September 19th 2017 City Council Meeting
Item # 6.1 BART Phase II Priorities and Preferred Alternatives

Roland Lebrun
ccss@msn.com
April 23 2017

Roland Lebrun
ccss@msn.com
BART Silicon Valley Phase II
Nov 19th 2014 meeting
Topics of conversation

Stacked Configuration
approaching/ exiting
Stations

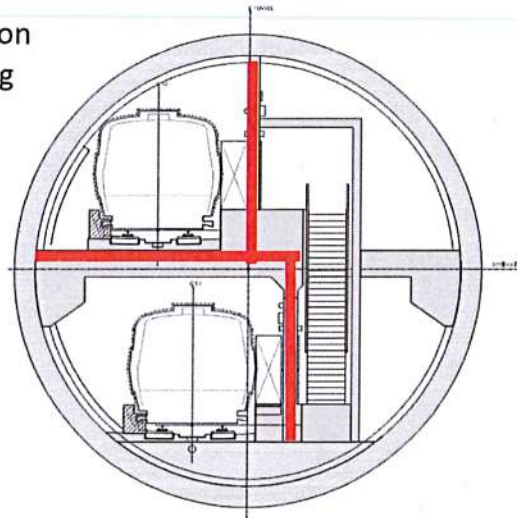
This criteria is met by the most of the designs presented to the Committee on 3/13/17.

Stacked Configuration at
Stations

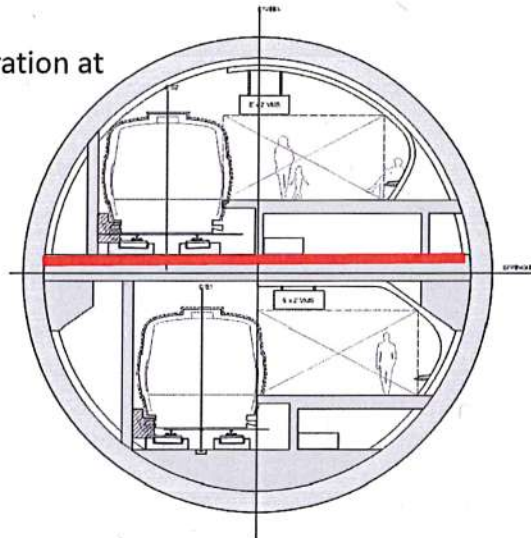
Please note that Platform Screen Doors (PSDs) are designed to stop smoke from entering the station platforms but are missing from the above diagram.

✗ Crossover configuration ✗

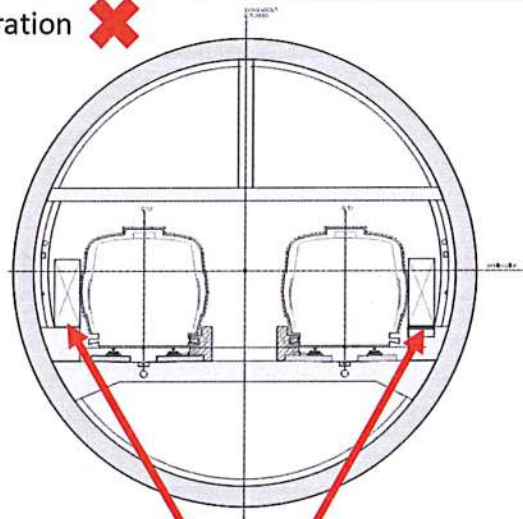
Non-existent doors/exits

The next fatal flaw is with the fire doors on opposite ends of the crossovers which are designed to prevent smoke/fire from entering the non-incident tunnel. **These doors cannot possibly be closed if there is a disabled train in the passage** at the time the ventilation system detects smoke in a tunnel, **making it impossible to increase the pressure in the non-incident tunnel to turn it into a place of relative safety and/or an escape route.**

Both flaws are resolved by the Crossrail twin bore crossover design which eliminates the need for fire doors across the tracks and provides cross-passages between the crossover tunnel and the adjacent running tunnel bores.

Station design issues

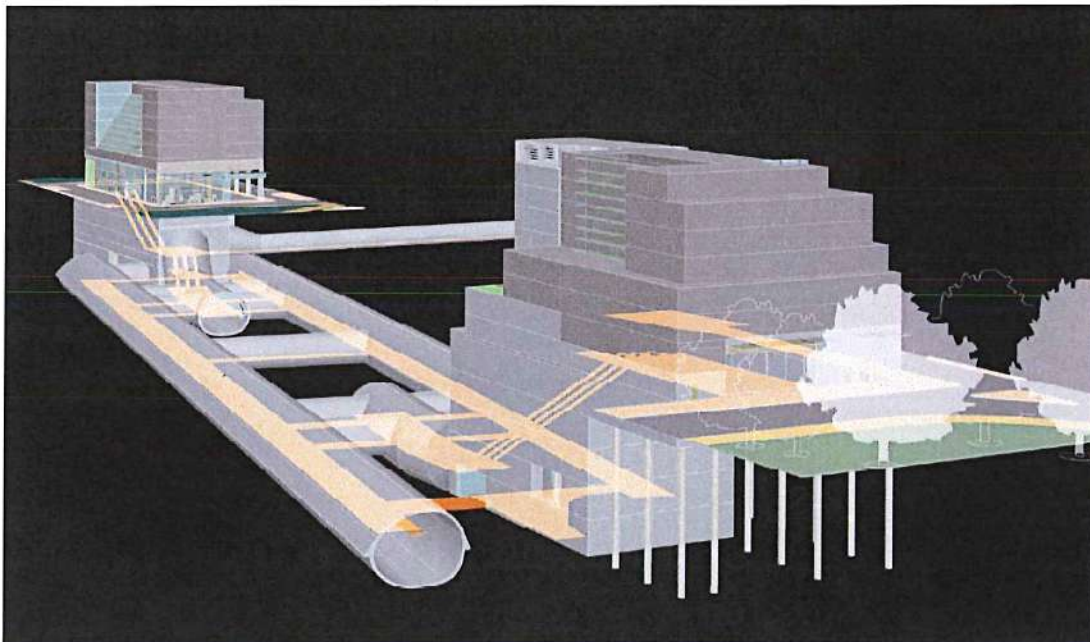
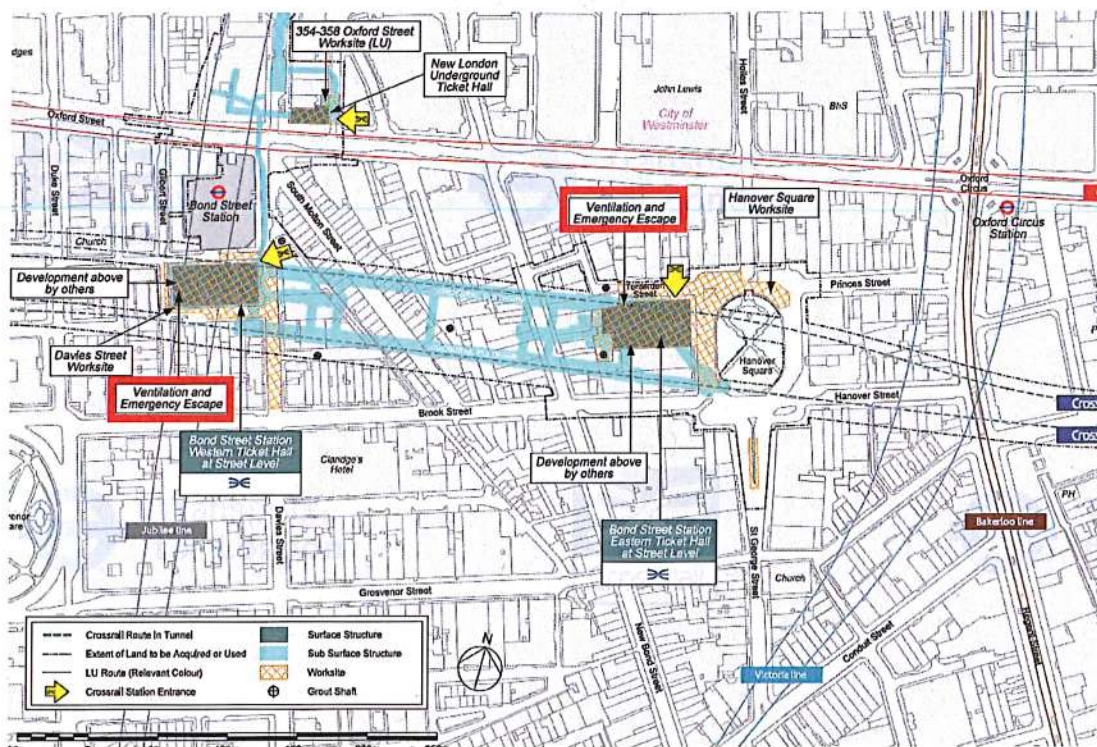
Once again, Crossrail station design is superior in an emergency because the incident platform (the platform connected to the incident tunnel) is connected via multiple cross-passages to the non-incident platform and/or the central circulation tunnel. Each platform and the central circulation tunnel are in turn connected to the station ticket halls located at the opposite ends of the platforms.

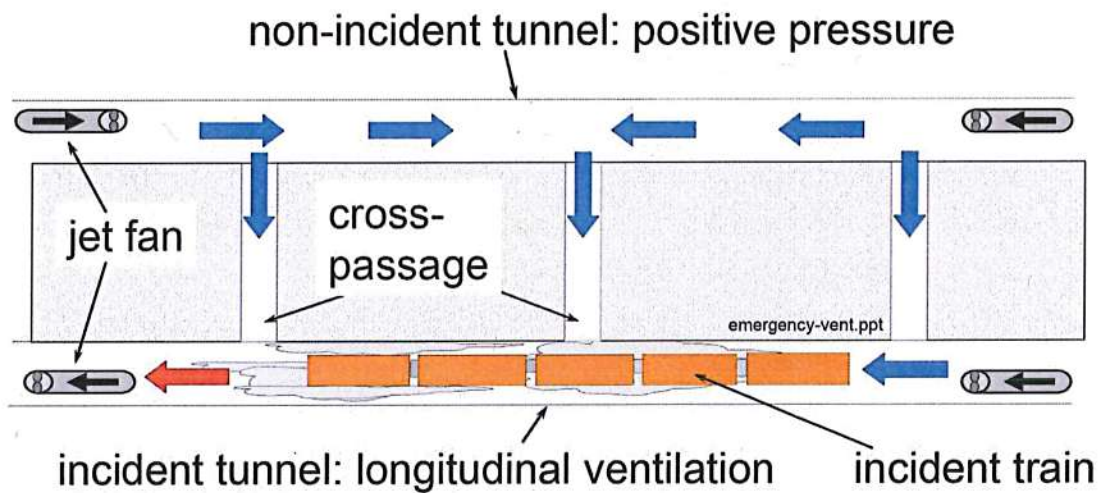
This design eliminates the need for passengers to walk up to 300 feet along a smoke-filled platform to reach an emergency exit

2) Alum Rock station @ 28th Street

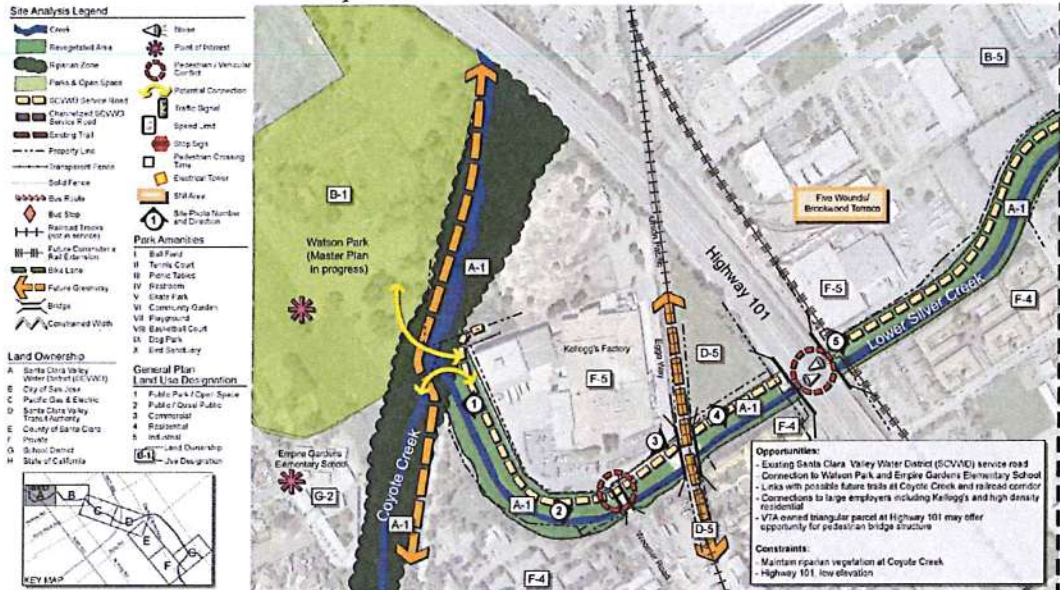
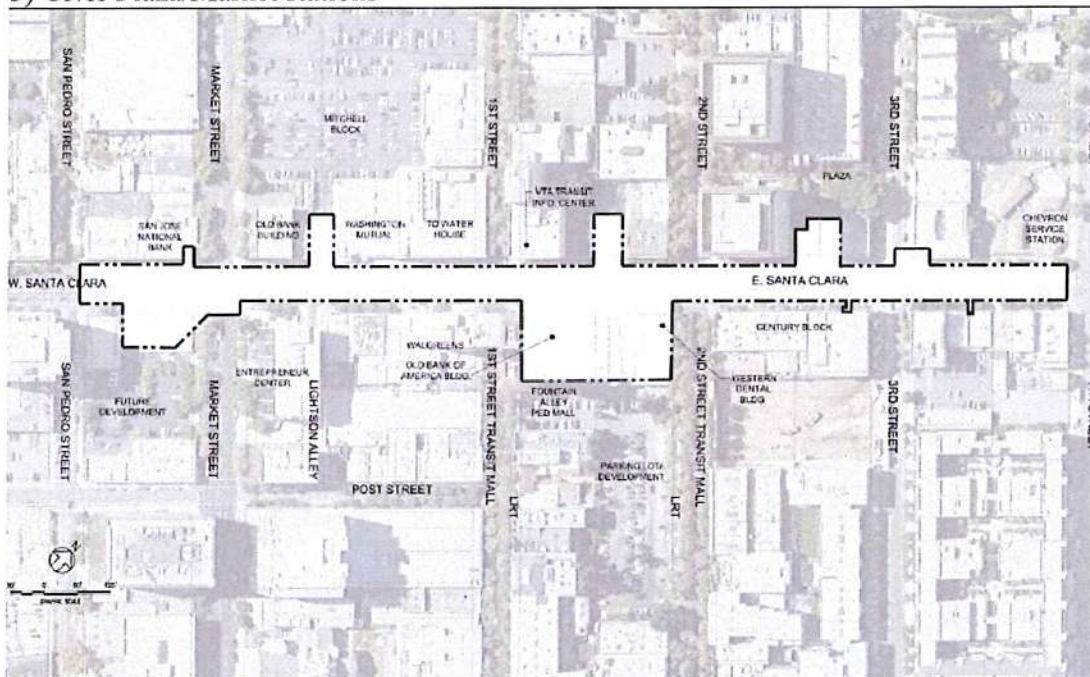
I would like to confirm that the only known station alignment that does not conflict with the December 2007 environmental clearance for the Lower Silver Creek Trail (<http://www.sanjoseca.gov/DocumentCenter/View/9361>) is the diagonal between 28th Street and 101 with a tunnel portal east of 101

3) Civic Plaza/Market stations

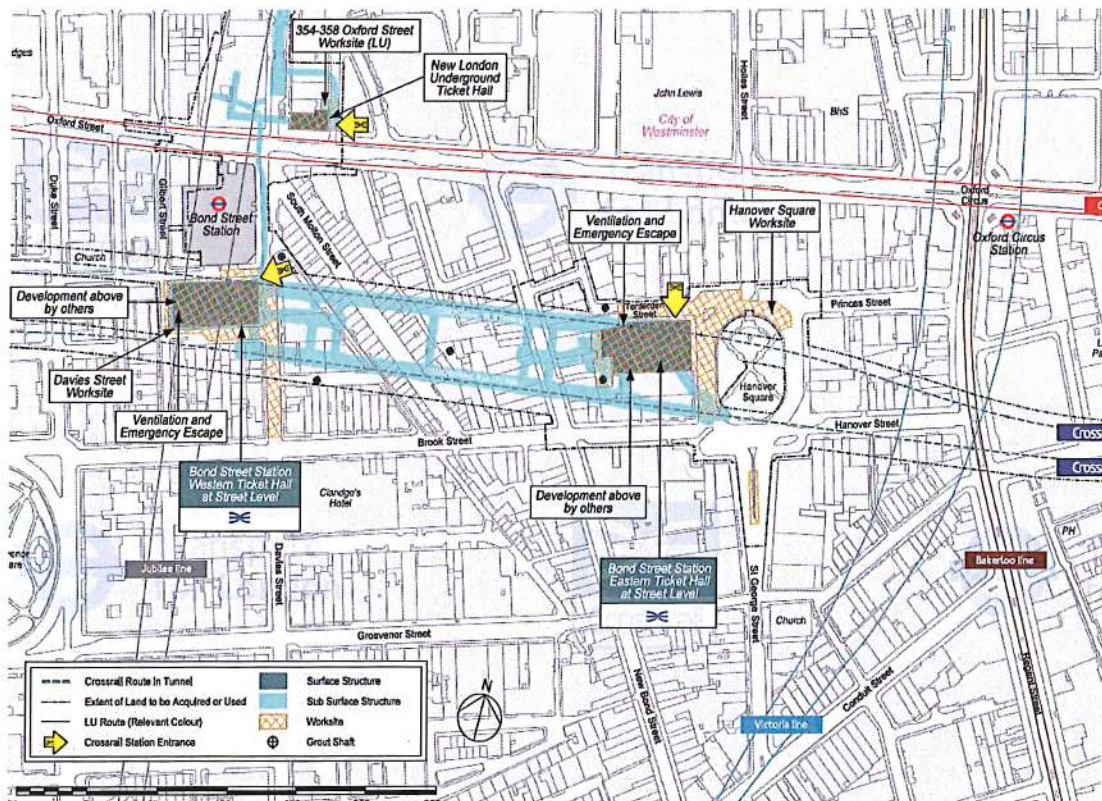
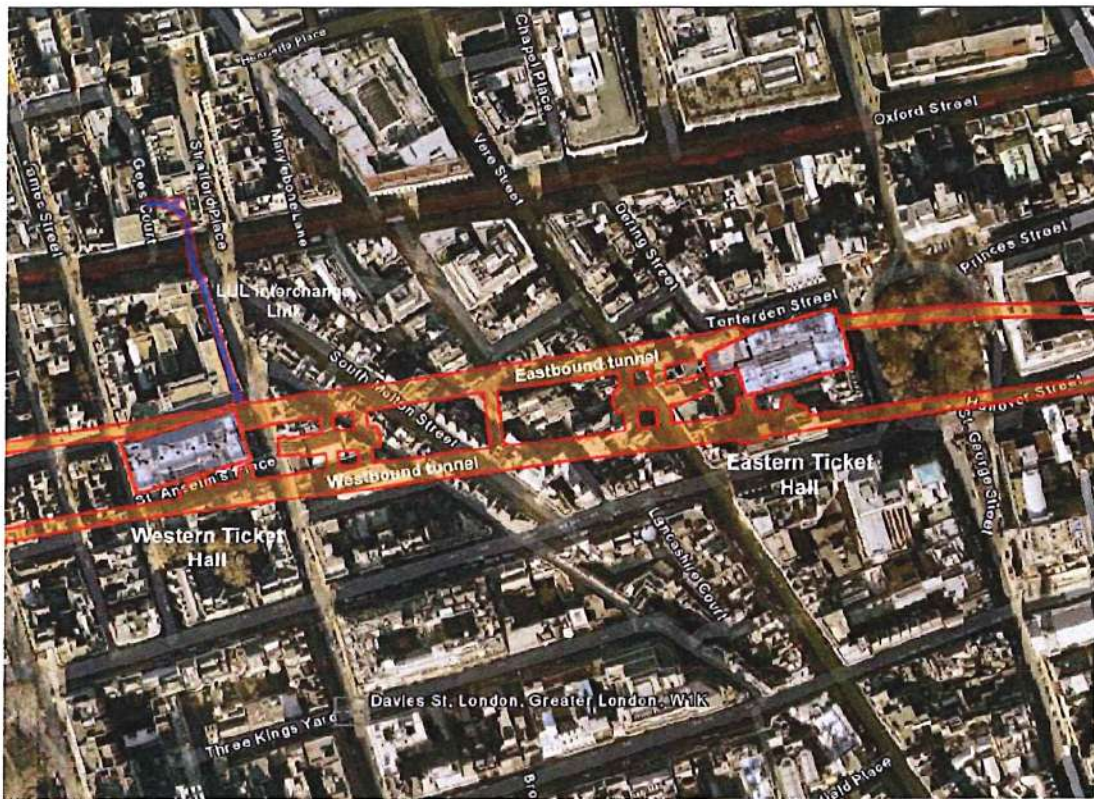
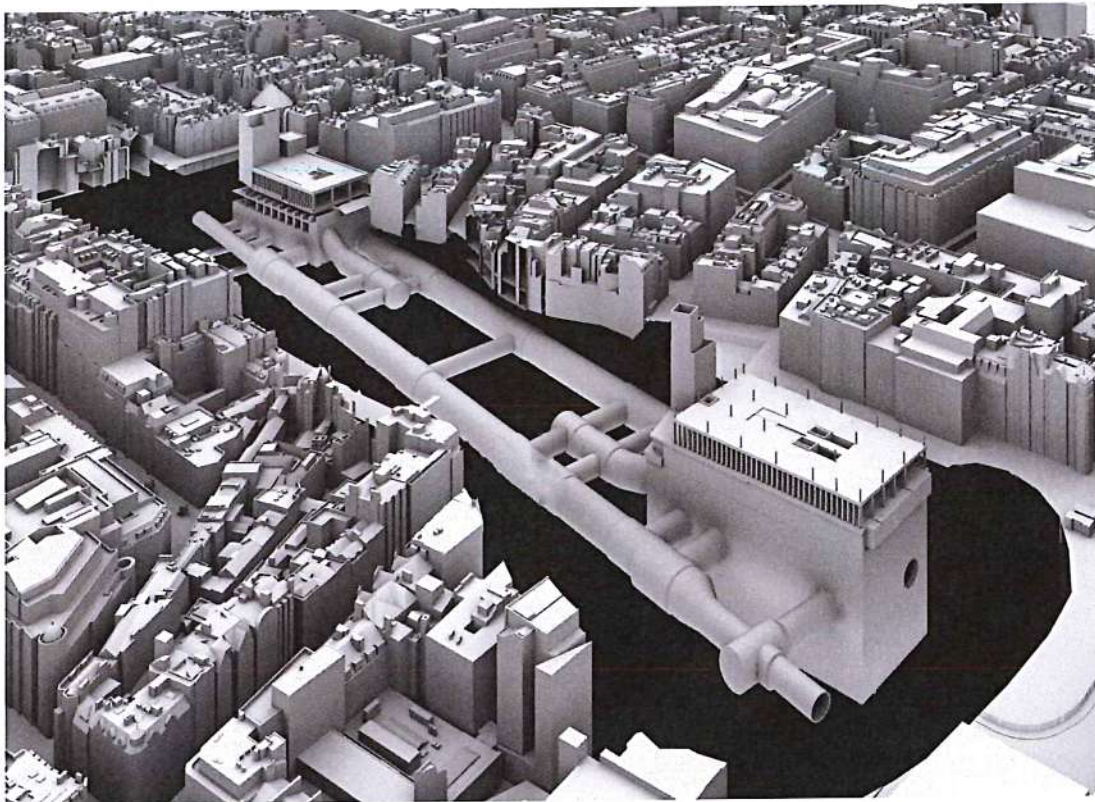
It is generally agreed that the two stations should be combined into a single station but this would entail a 1,700-foot cut and cover trench under Santa Clara Street, including crossovers. I would like to spend some time discussing the relative merits of an alternate method of construction, specifically the Bond Street Crossrail station in Central London.

4) Diridon Station

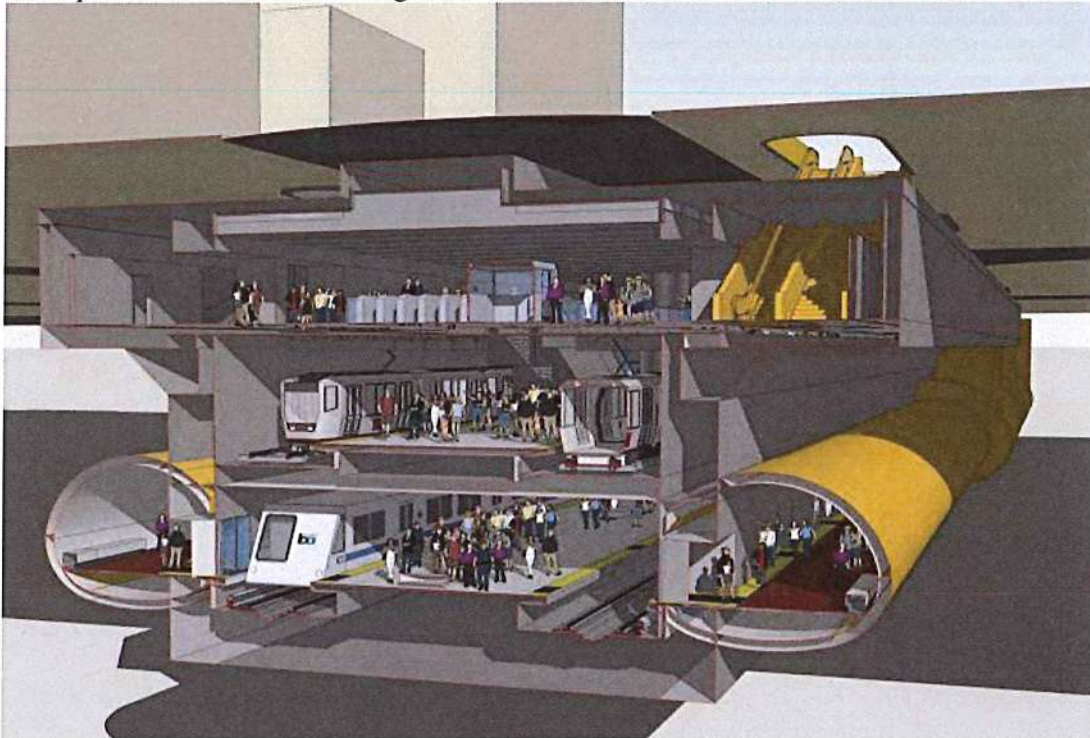
- Restoring the original BART station box alignment parallel to Santa Clara Street
- Relocating the parking structure to the other side of Santa Clara to act as a buffer for the transit center pedestrian core

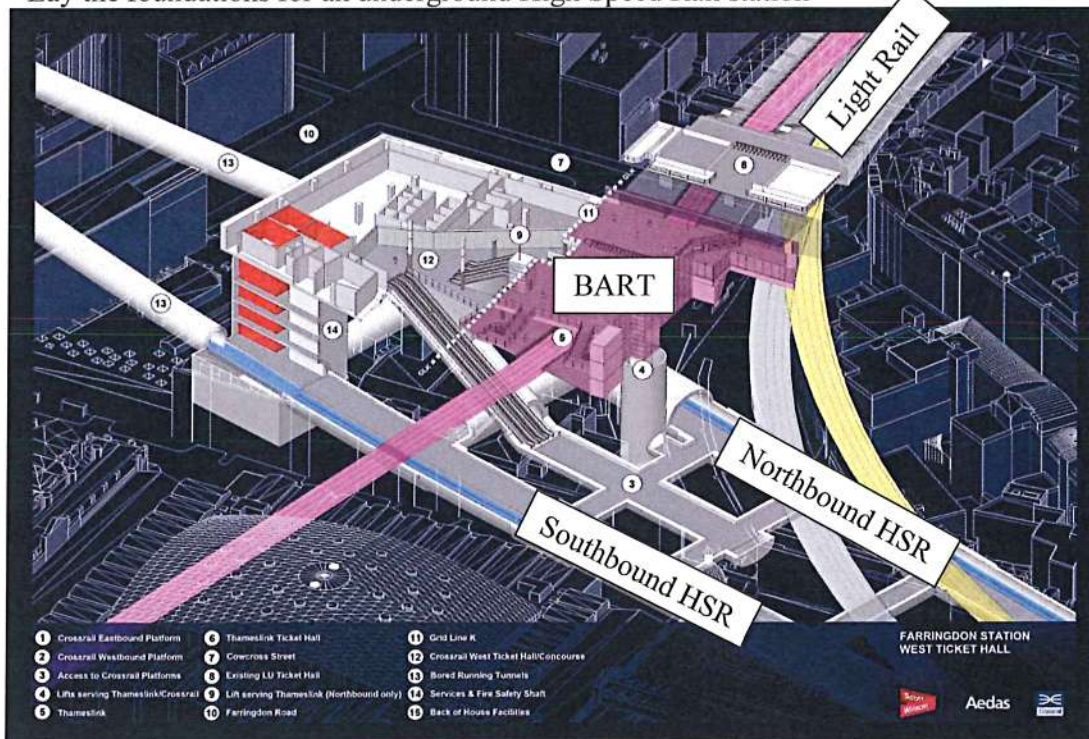
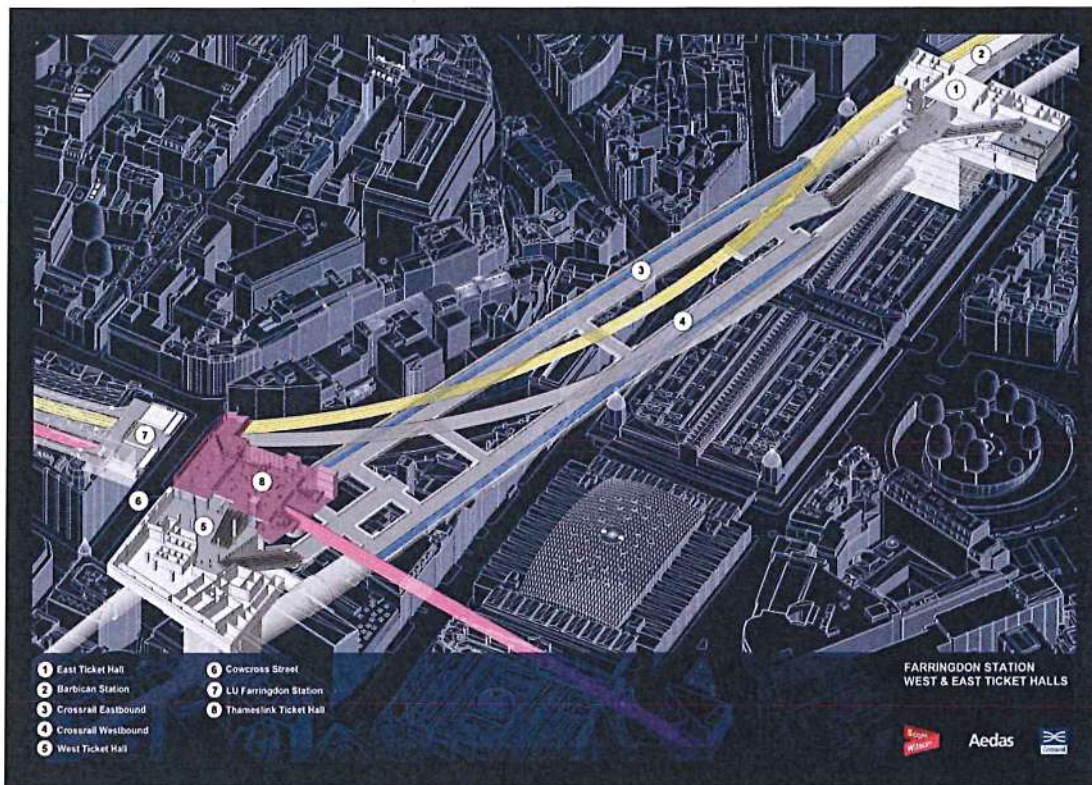
- Addressing capacity issues similar to those at Montgomery/Embarcadero by replacing the Diridon BART central platform with 2 central tracks separating east and westbound outer platforms instead of adding outer tunnels at a cost of \$900M at a later date:
